UNITED STATES PATENT AND TRADEMARK OFFICE

APPLICATION NO.	FILING DATE	FIRST NAMED INVENTOR	ATTORNEY DOCKET NO.	CONFIRMATION NO.
10/750,580	12/29/2003	Robert E. Higashi	H0004490 (1100.1226101)	8588

Office Action Summary	Application No. 10/750,580	Applicant(s) HIGASHI ET AL.	
	Examiner Thinh T. Nguyen	Art Unit 2818

DETAILED OFFICE ACTION

Fig. 1a

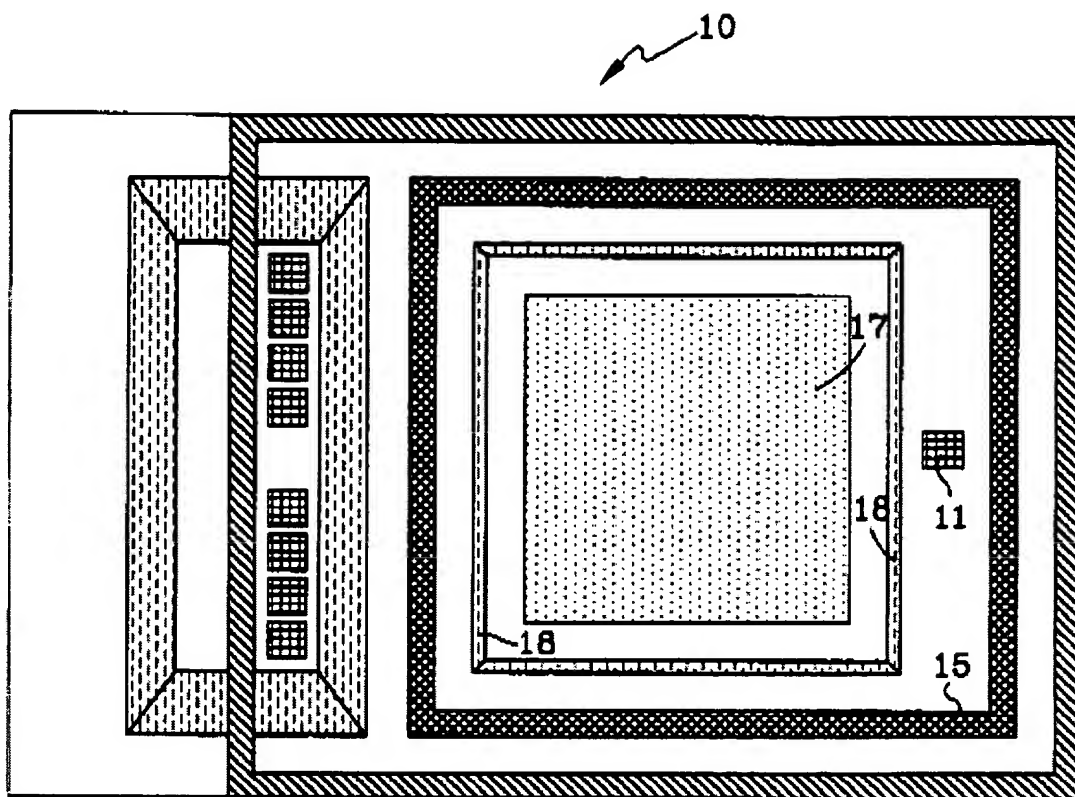
With regard to claim 1 wood discloses (in the abstract, in fig 1a, 1b) an integrated package comprising: a first wafer (fig 1b reference 14) having a first surface; a second wafer (fig 1b reference 13) having a first surface bonded at a first perimeter (fig 1a reference 15) to the first surface of the first wafer; and a recess formed (fig 1b reference 18) in the first surface of the first wafer in a second perimeter (fig 1a, reference 17) situated within the first perimeter for a window situated within the second perimeter.

Fig. 1b

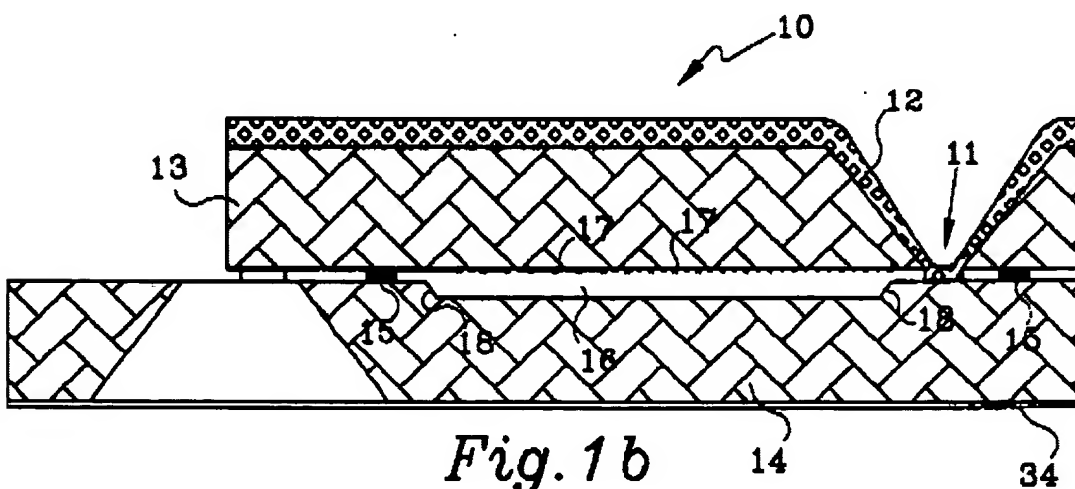
With regard to claim 4, Wood discloses a seal (fig 1b reference 15 ,column 2 lines 14-15) between the first and the second wafer. The rational why claim 4 is obvious over Wood et al in view of Higashi and in further view of Banish et al, has been set forth above.
